Amdt. to OL/ change to tech specs... concerns changes in the organizational structure of Sec. 6.0 of the tech specs & corrects typographical errors in tech specs.....

H. B. ROBINSON STEAM ELECTRIC PLANT, UNIT NO. 2
DOCKET 50-261
LICENSE NO. DPR-23

REQUEST FOR LICENSE AMENDMENT-REVISION OF TECHNICAL SPECIFICATIONS

Figure 6.2-1

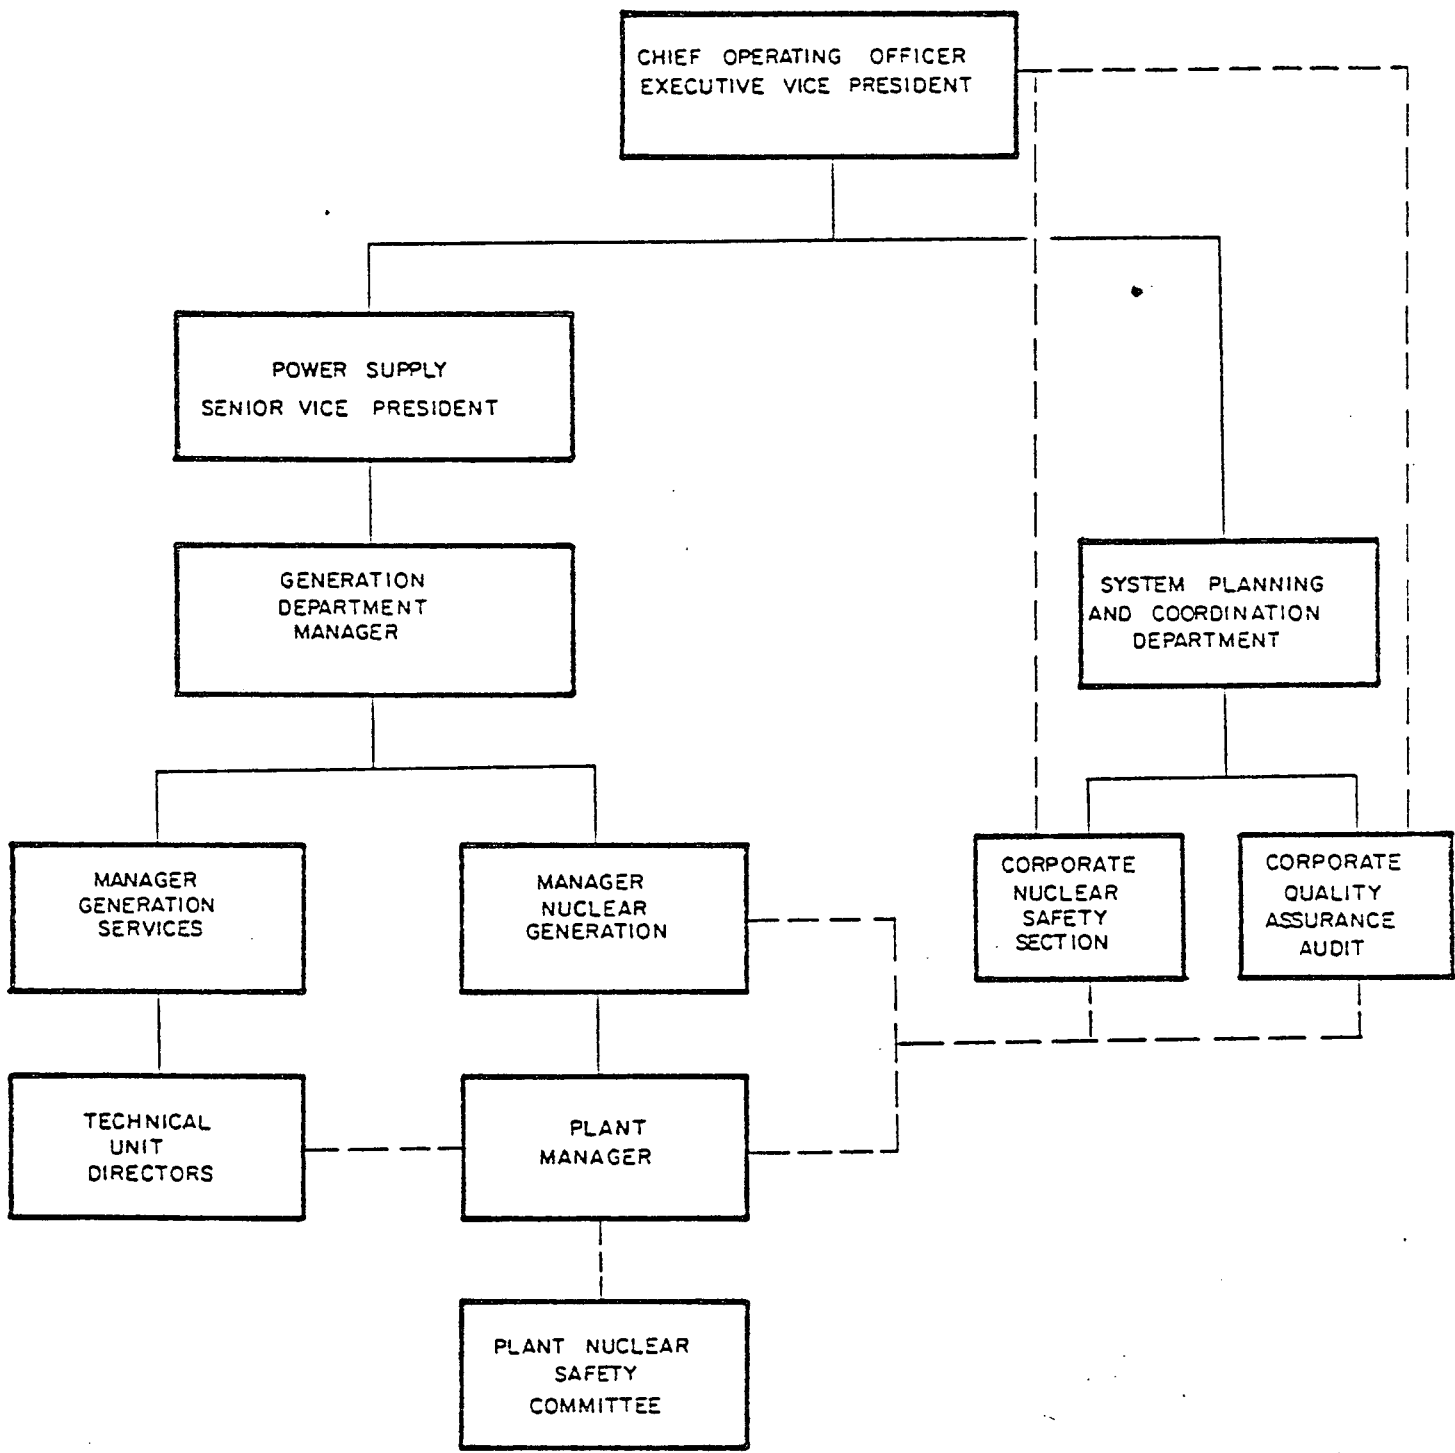
In accordance with the Code of Federal Regulations, Title 10, Part 50.90 and Part 2.101, Carolina Power & Light Company (CP&L) hereby requests a revision to the Technical Specifications for its H. B. Robinson Steam Electric Plant, Unit No. 2. This request reflects changes in the organizational structure of Section 6.0 of the Technical Specifications and corrects typographical errors in the Technical Specifications.
